WorldSID-50M Head Core Update

Publication Date: August 2018

Humanetics has updated the head core of the WorldSID-50M to prevent the mounting of the tri-axial accelerometer upside down.

W50-00103

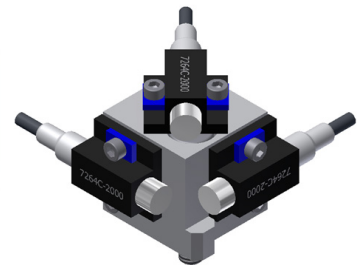
- Updated the mounting hole for the uniaxial accelerometer mounting block (M2 to an M3)
- Released a new uniaxial accelerometer mounting block (W50-00103) and mounting block kit (W50-00113)
- Released a new head core (W50-10007-1) and no longer selling the old design (W50-10007)

** If a customer orders a new dummy or headcore and plans to use a uniaxial accelerometer in the head, the W50-00113 mounting block kit will need to be ordered as well.*

Existing Head Core

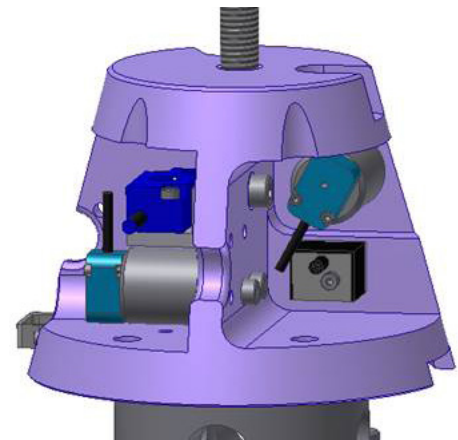
To avoid mounting errors on the existing head core design when installing the triaxial accelerometer, ensure that it is oriented as shown below. The etchings/markings on the accelerometer should be facing downwards. If the accelerometer is installed incorrectly, this will lead to incorrect test results.

New Head Core	
W50-10007-1	HEAD CORE ASSEMBLY

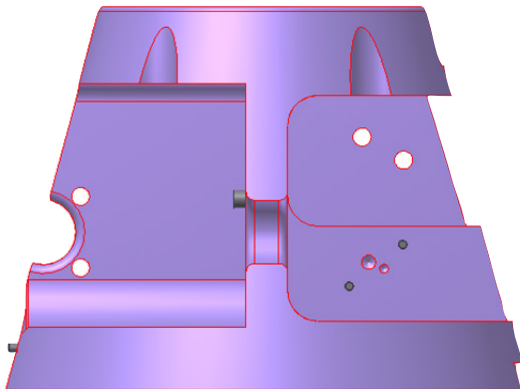
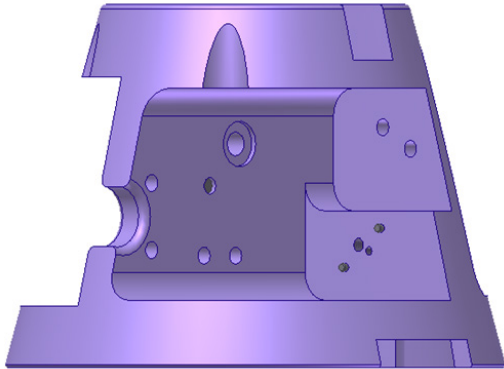
With the old design, users were able to use both mounting holes to assemble the tri-axial accelerometer to the head core. One of the mounting holes, that was intended for the uniaxial accelerometer mount, would mount the tri-axial accelerometer upside down. Humanetics updated the mounting hole pattern in order to eliminate the ability to install the tri-axial accelerometer upside down.
